LA3215C - Request-for-Tenders under Open (OJEU) Procedure for the Supply, Delivery, Installation and Commissioning of a Suite of Plasma Etcher & Plasma Deposition Tools, [4 Lots] for Tyndall National Institute, University College Cork (UCC)

Tyndall Sub-Fab etch & PECVD vacuum-pumps A.png

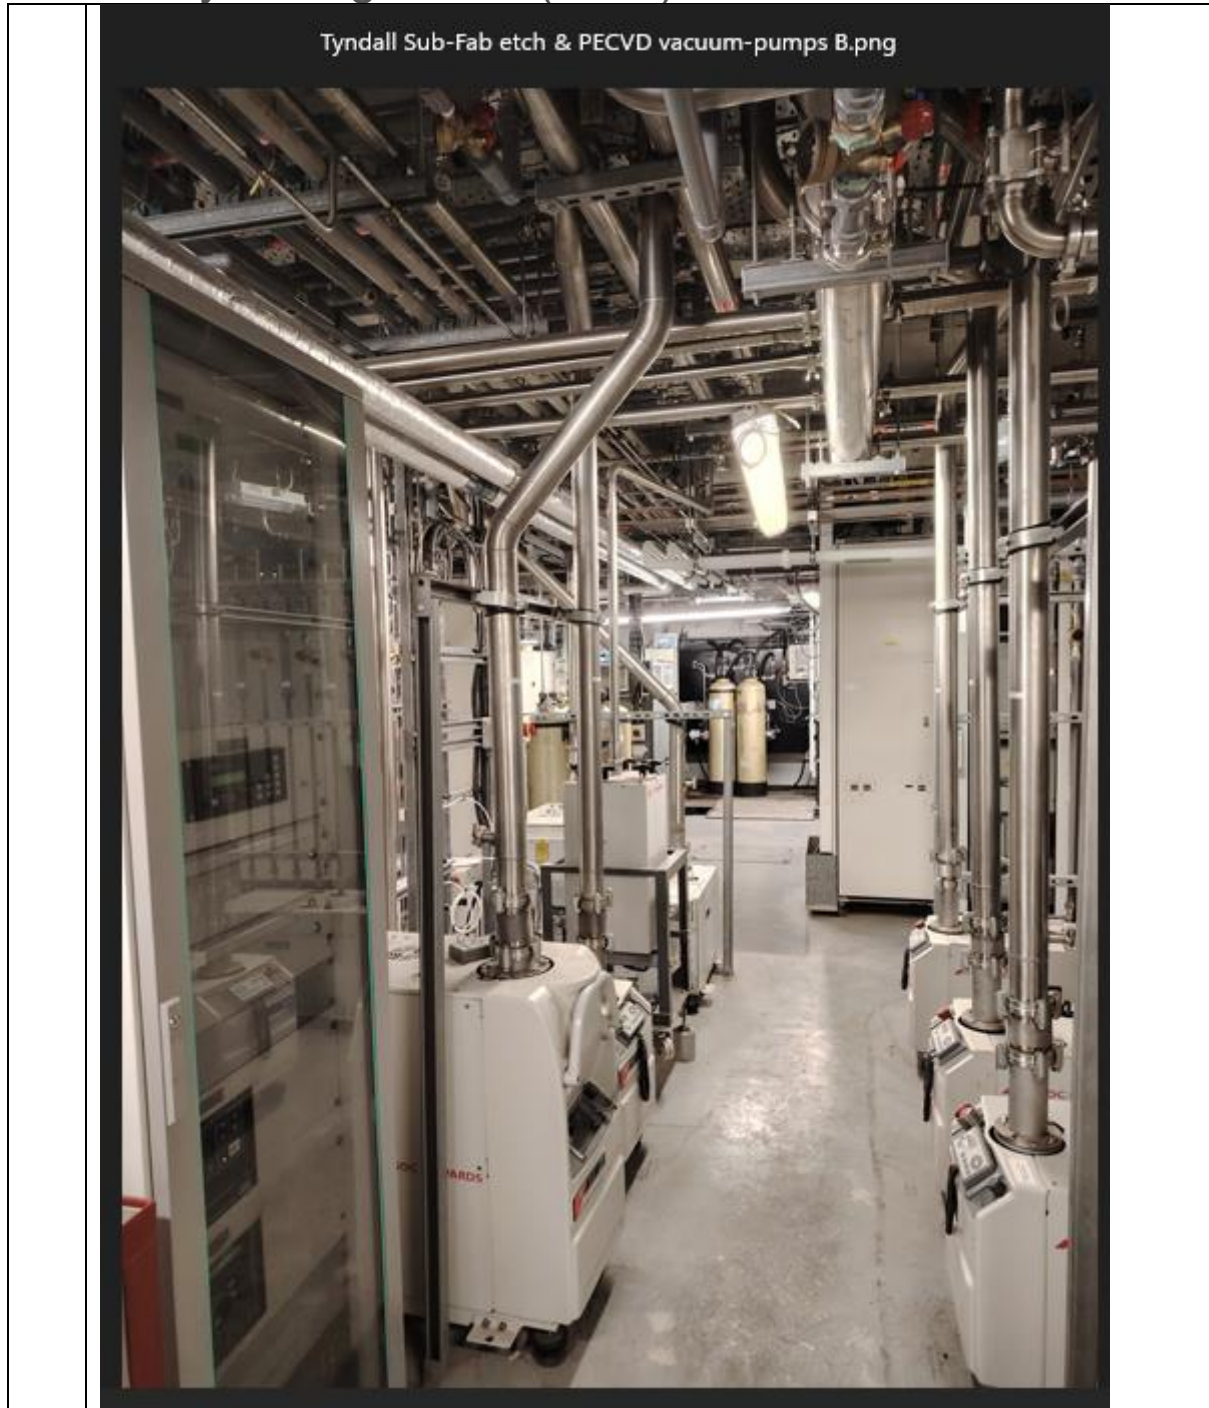
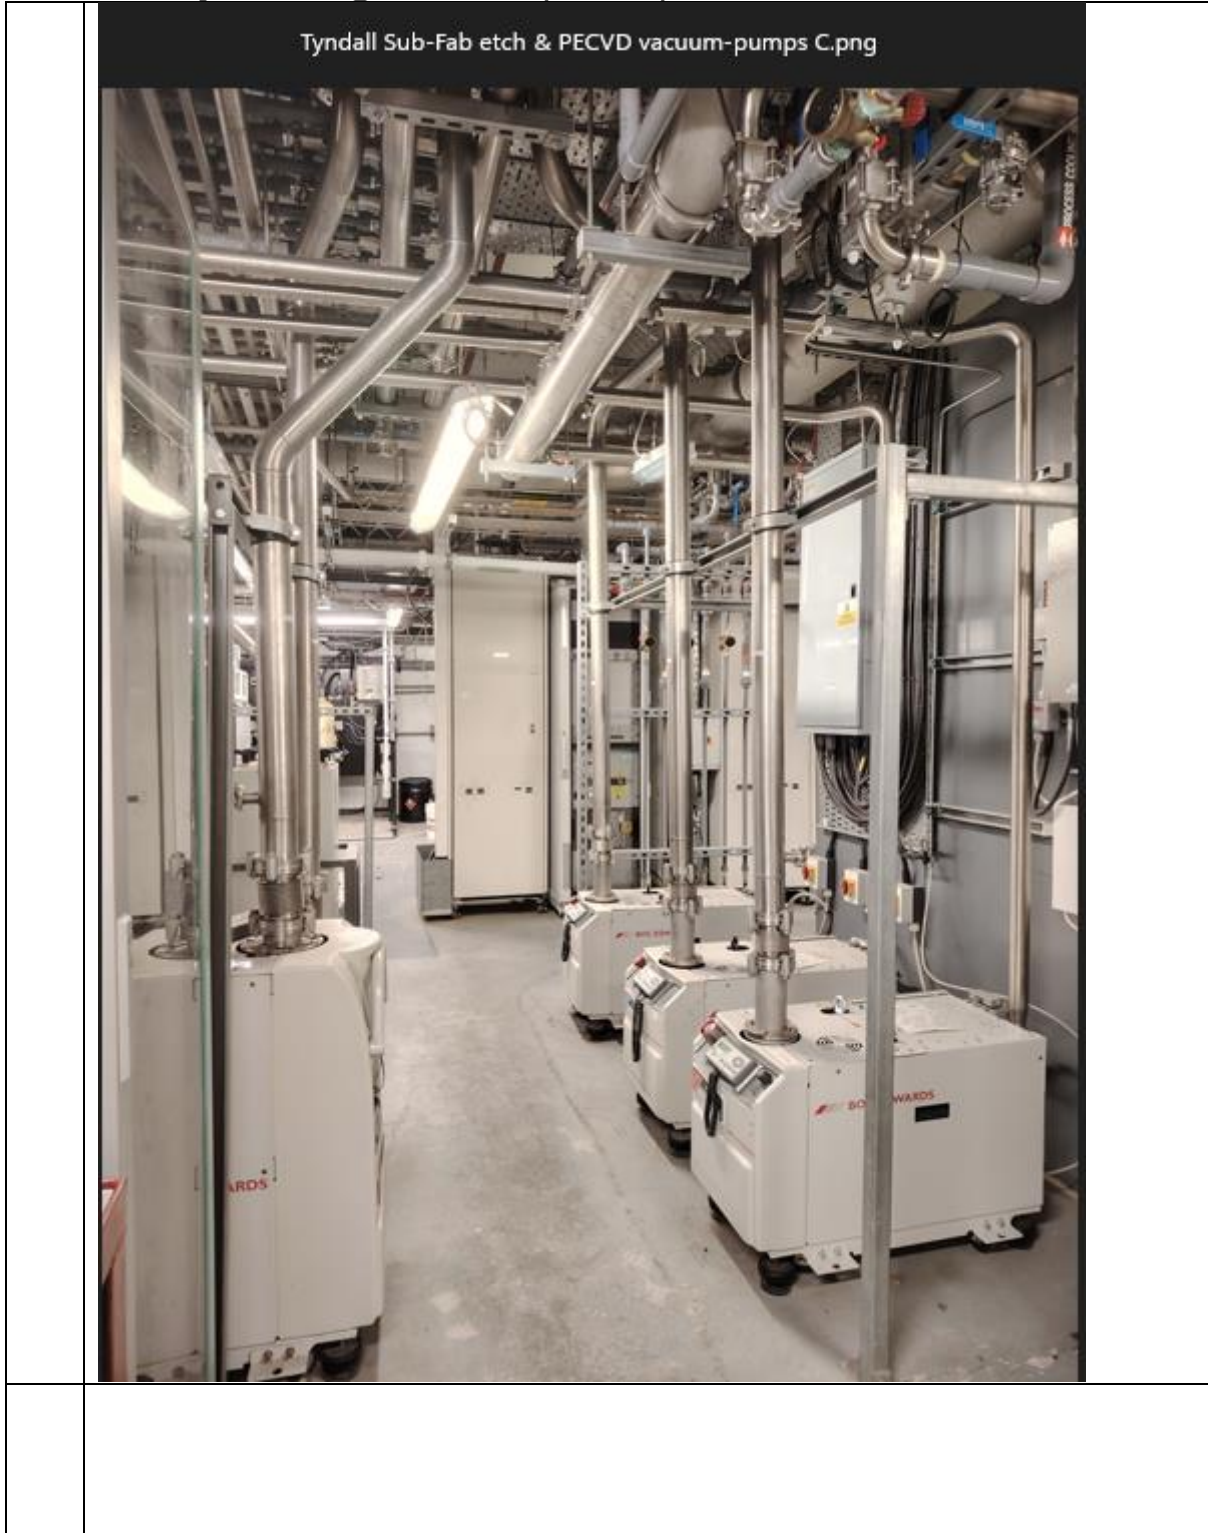
<p>Q12</p>	<p>thanks for the answer.</p> <p>I can understand the pump and the system are located at different floor and there will be distance in-between. I would like to understand how pipe between the pump and the system is connected, will it has turns? Normally each of the turn will sacrifice 20 percents of the pump efficiency, understanding how the pipeline is arranged will us to configured the right pump.</p> <p>besides, I see the machine should fit within 5 m2, i would also like to understand is there any requirement of the length and the weight?</p>
<p>A12</p>	<p><i>The vacuum pumps will be located in the Sub-Fab area on a separate floor underneath the cleanroom. The pump lines will have a maximum of 2x right-angle (90°) turns or 1x right-angle + 1x oblique (< 90°) turns; these are typically located directly above the pump itself and directly underneath the through-floor connection to the tool location at Sub-Fab ceiling-level, as the pumps may not sit directly underneath the tool itself. Please see attached photos of the Sub-Fab configuration for reference. Also, please note that as-per specifications A33 / A37, options of other vacuum pumps (which can include models with higher pump capacity than the base model recommended to meet the requirements of specification A32 / A36) should be provided by the Tenderers.</i></p> <p><i>As-per Appendix A, all four tools must fit within the 20 m² area highlighted (red box), with approximately 5 m² per-tool. Because of the necessity for thru-wall configuration, a maximum length of 2.5 m is preferred to allow for maintenance access directly behind the tool in the service chase.</i></p>

In relation to weight requirements, it is preferred that the maximum weight is < 2 metric tons per-tool, but this will be assessed on a case-by-case basis by a structural engineer for Tyndall / UCC.

See additional images below.
